**PLANNING PANEL (SOUTH)**  
**SUPPLEMENTARY REPORT**

<b>Panel Reference</b>	<b>PPSSTH-166</b>
<b>DA Number</b>	<b>DA0350/2022</b>
<b>LGA</b>	<b>Shellharbour City Council</b>
<b>Proposed Development</b>	Two residential flat buildings and one building with shop top housing comprising a total of 155 apartments and retail space (total 330sqm).
<b>Development Characterisation</b>	<b>Residential Flat Building</b> <b>Shop Top housing</b>
<b>Location</b>	Lots 4204 and 4205 DP 1254978 and lot 4006 DP1219051 5 and 6 Civic Avenue and 5 Waterfront Promenade, Shell Cove Alternative address – 9 Waterfront Parade, Shell Cove
<b>Applicant/Owner</b>	Australand Corp. (Frasers Australia) - Applicant Shellharbour City Council (landowner)
<b>Date of DA lodgement</b>	1 October 2021
<b>Report prepared by</b>	Madeline Cartwright, Principal Planner – Development Assessment
<b>Report Endorsed by</b>	Mathew Rawson, Manager – Planning and Urban Release
<b>Date of report</b>	15 June 2023

*Figure 1 – overshadowing diagram*

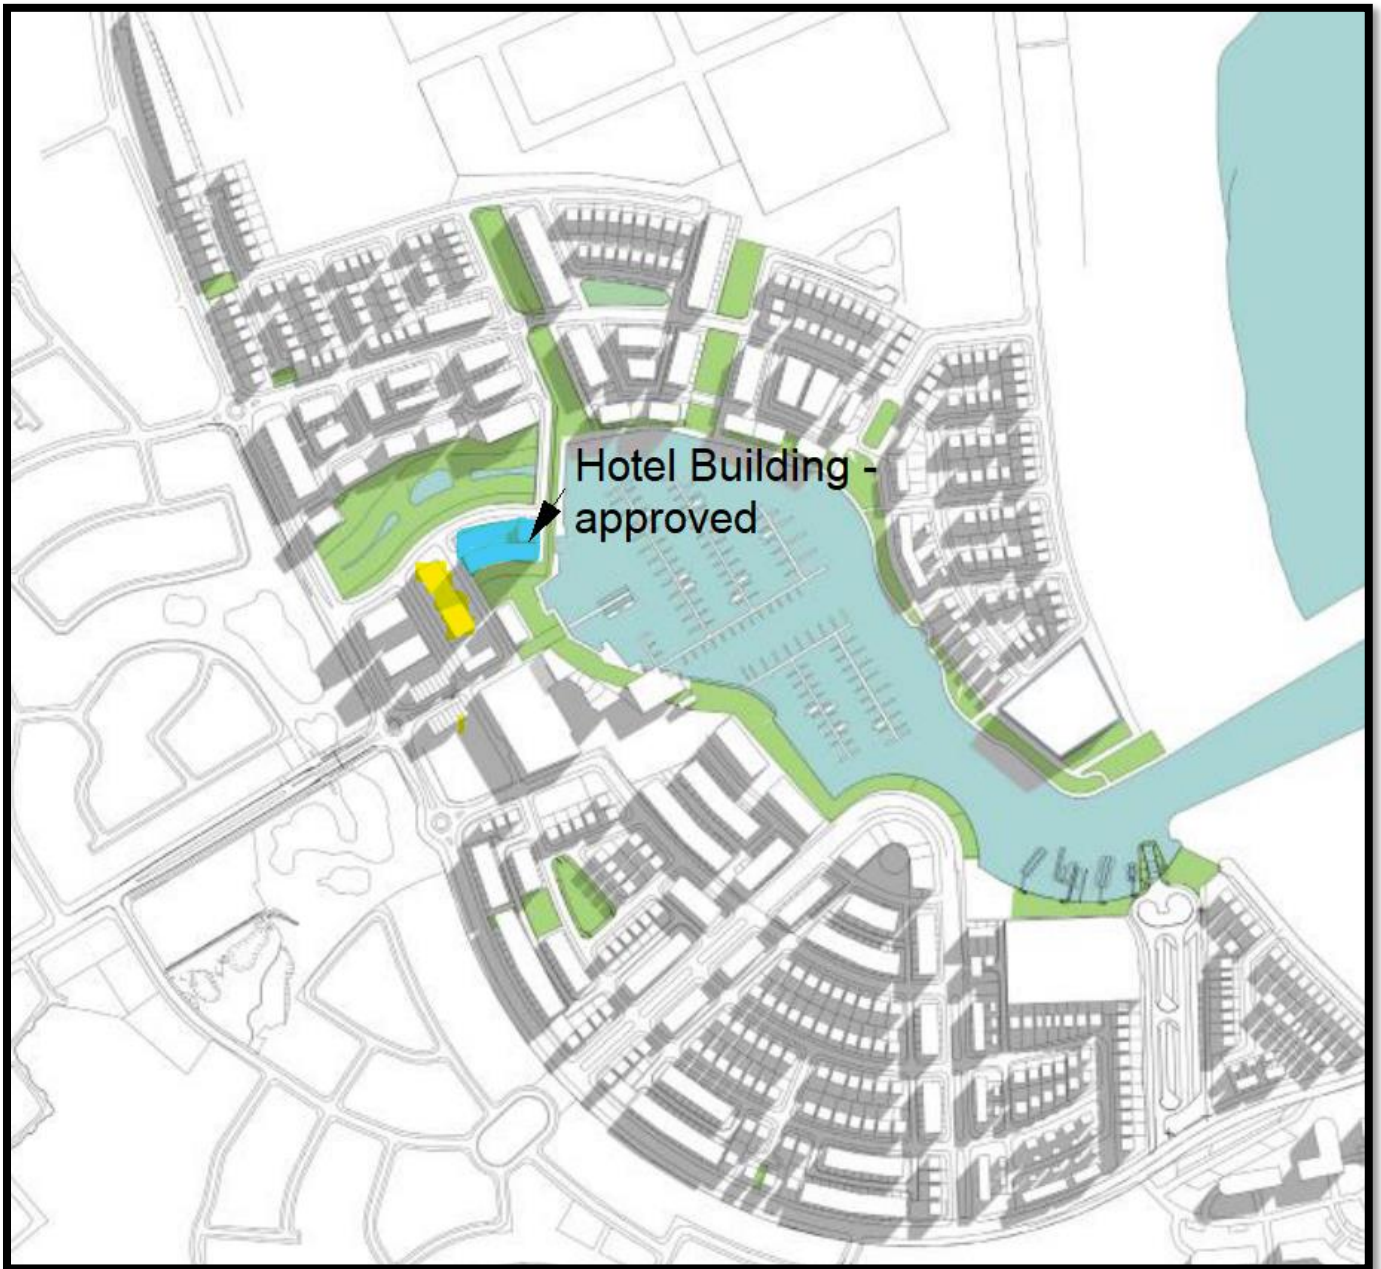
The Revised Concept Plan Design Report ([majorprojects.accelo.com/public/6fb24ccf626343aae48621c9c6e157f0/COX\\_20180731\\_ShellCove\\_RevCepPlan\\_DesReport\\_V33.pdf](https://majorprojects.accelo.com/public/6fb24ccf626343aae48621c9c6e157f0/COX_20180731_ShellCove_RevCepPlan_DesReport_V33.pdf)) which forms part of the approved documents of the Concept Approval mod 1 includes analysis of the overshadowing impact of the built form, with building envelopes shown as highlighted below in figure 1. The overshadowing impact of the approved hotel building (highlighted in blue) at 9am as shown in figure 1 can be seen as impacting lot 4204 (highlighted in yellow) and the future residential building.

Figure 4 - shadow diagram 12noon mid-winter

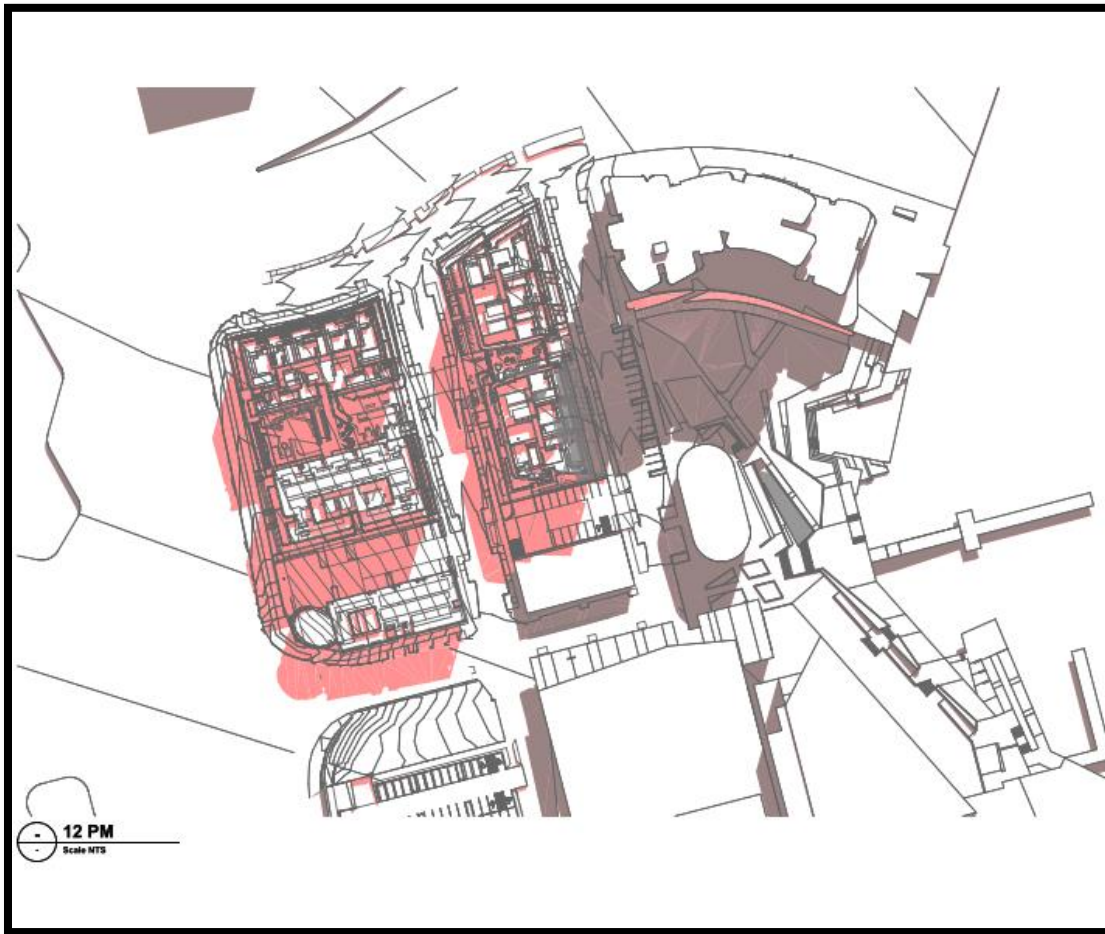
The submitted shadow diagrams included as attachment 11 of the Council Assessment Report and as figure 3 and 4 below for the more detailed overshadowing impact at 9am and 12pm mid-winter of the hotel building on the development, specifically building B. The approved hotel building is shown to overshadow the majority of lot 4204 in the early morning. Importantly the shadow diagrams also include the impact from the planned but not yet approved oval shaped library/community facility located to the south-east of the subject site.

Figure 5 – COS for building A and B

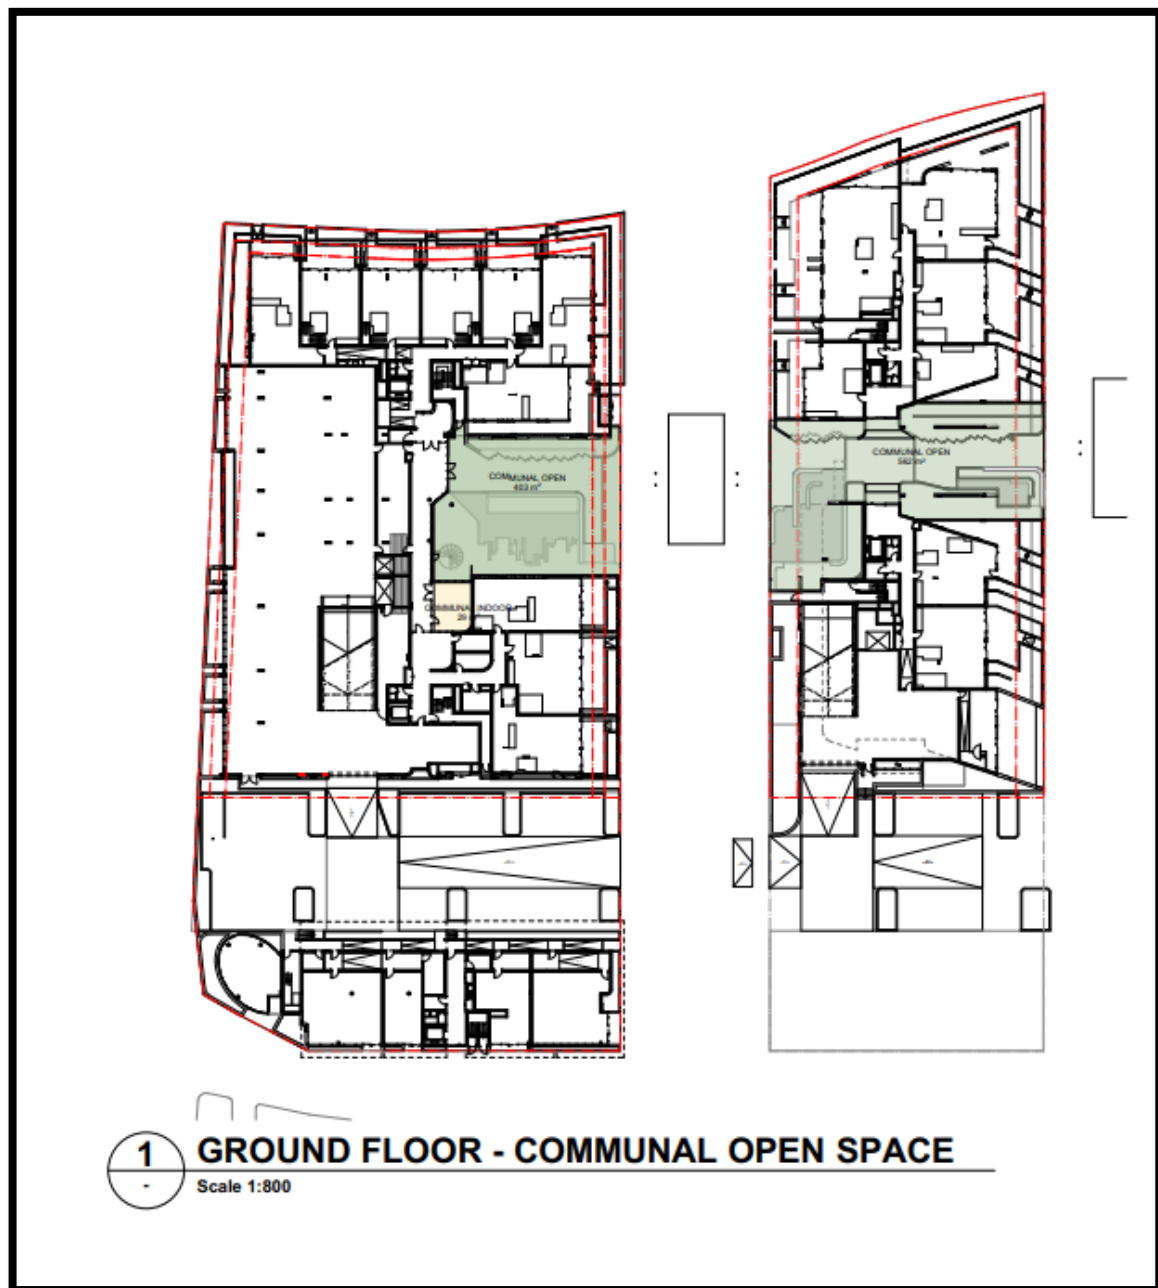
The applicant has included COS areas on the ground floor of both buildings. Building A has a large landscaped and seating area as part of the entrance to the building as shown in figure 5 below, this area totals 403 sqm. The applicant has specified that this area will be for residents and visitors only and provide meeting spots and spaces to relax as well as an attractive entrance to the building.

The applicant has also included the area included as the through site link through lot 4204. This is shown in figure 5 above. The through site link provides public access from Civic Avenue to Waterfront Parade and to the public open space and marina beyond. The design also includes landscape beds and seating areas which the applicant envisages can be used for relaxing and as a meeting point.

Whilst Council has questioned the inclusion of this publicly accessible area as COS it is acknowledged that the design results in a positive urban design outcome and also allows permeability to the future public open space to the east of building B and towards the Marina. This is in-keeping with the Urban Design Guidelines for the precinct and provides a favourable outcome for such a long, narrow site.

and in acknowledgment of the benefits to the public access that will be provided, Council recommends that the area of the through site link is included in the COS area.

*X. Public right of access must be maintained from Waterfront Promenade to Civic Avenue via the through site link in Building B in Lot 4204 DP1219051 in perpetuity.*
